# PLANNING REPORT

# Application reference: 23/0529/FUL

Rear Of, 35 Twickenham Road, Teddington, TW11 8AH

Erection of one detached villa comprising two semi-detached dwelling houses with associated parking and landscaping

Figure 18. Figures taken from Daylight Sunlight Assessment

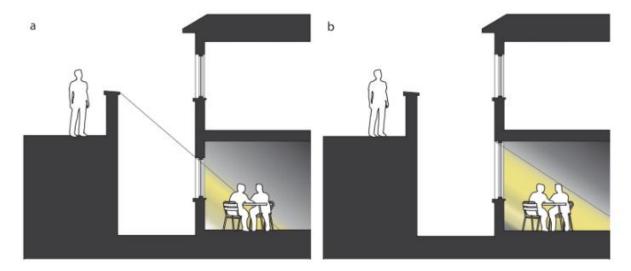
The Council do not accept that the daylight levels of 22.48% VSC for window W1 are acceptable as 27% is the BRE baseline acceptable level. A lower percentage to this requires special measures as described in paragraph 2.1.6.

Figure 20. Site Plan Approved Scheme 17/0788/FUL

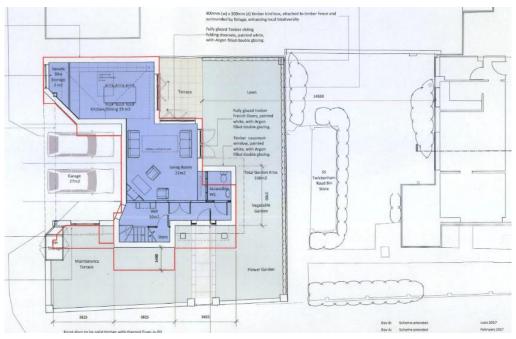
The approved scheme 17/0788/FUL was accompanied by a Daylight and Sunlight Report by Waterslade dated 29 June 2017. The approved scheme was set back a similar distance as this proposal with a graduated layout.

Figure 25. Car Parking Layout

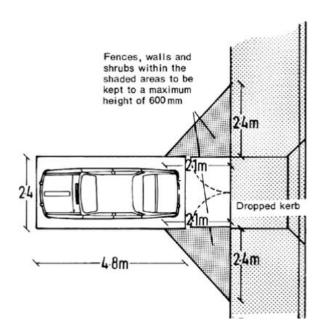
A revised block plan was received to provide the additional space Updated Block Plan - Parking Layout 17 Apr 2023. This replaces the parking space from the side road to Manor Road, however as there is no crossover serving this car parking space. It is noted that the absence of sightlines on the drawings was a reason for refusal in 16/2171/FUL. In this case the car parking spaces were off the adjacent private road. However, they are necessary. There is also a lamppost in close proximity to this proposed car parking space which is completely unacceptable.

Additionally, the visibility splays of 2.4m by 2.1m as shown on the diagram below need to be achieved.

This second car parking space is accessed from the private road but is parallel to the public footway and appears to be only 4.8m long and 2.4m wide. The adequate visibility splays have not been provided for this car parking space for the second car parking space.
